URGENT - Field Safety Notice

Philips IntelliVue Information Center iX (revision A.XX (where XX is 00 to 02) option LAB, PIIC iX revision B.00 option LAB and PIIC iX revision B.0 Enterprise Server (option LAB is bundled)):

HOW TO IDENTIFY AFFECTED PRODUCTS

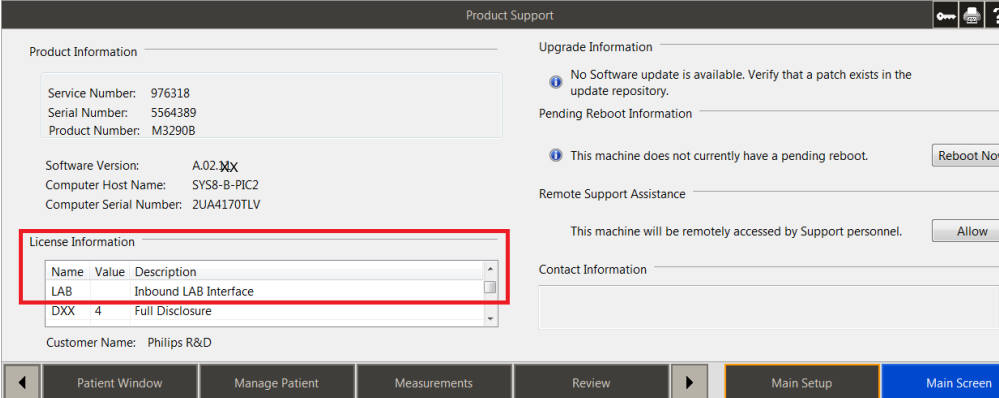
PIIC iX Revision – Identify the affected product by clicking on the Philips watermark on the PIIC iX surveillance display. This will bring up the Product Support Page.

This screen shows the licensed features that have been included. All affected units will show the option LAB active in the License Information.
